Docket Nos.: 50-369  
and 50-370

My letter dated August 22, 1986, forwarded Amendments 60 and 41 to Facility Operating License Nos. NPF-9 and NPF-17 for the McGuire Nuclear Station, Units 1 and 2. An incorrect overleaf page was erroneously transmitted with that letter. Please replace page 5-5 of Amendments 60 and 41 with the attached, revised page.

McGuire Nuclear Station

FIGURE 5.1-4

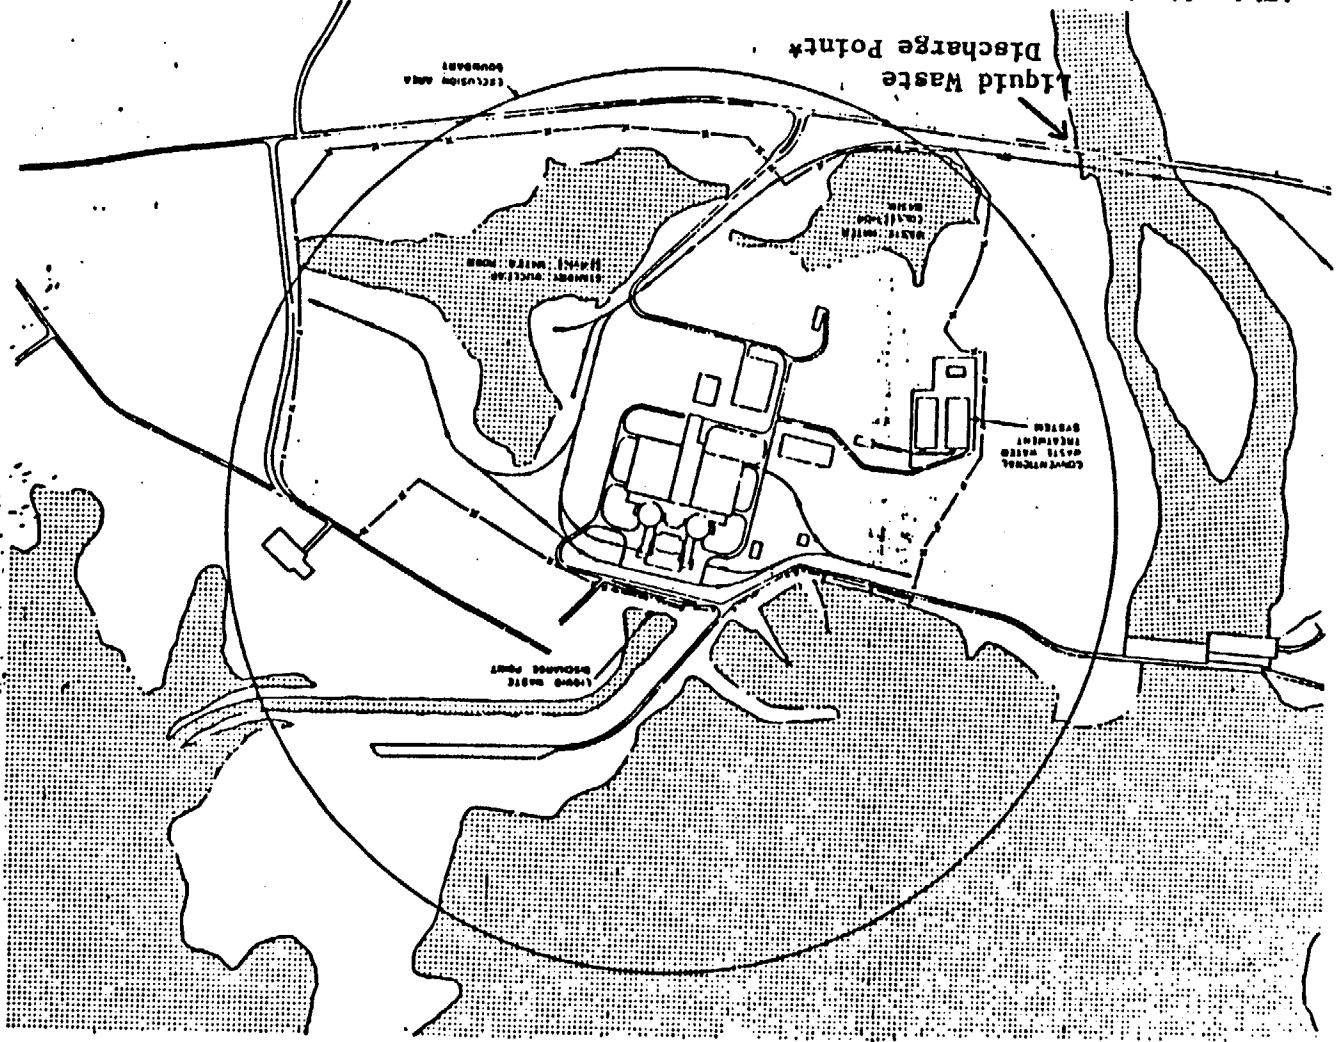
\*This discharge point is authorized for a one-time discharge of water from the Conventional Wastewater Basin which contains trace amounts of tritium in addition to the normally processed effluents of the Waste Water Collection Basin, effective June 20, 1986.
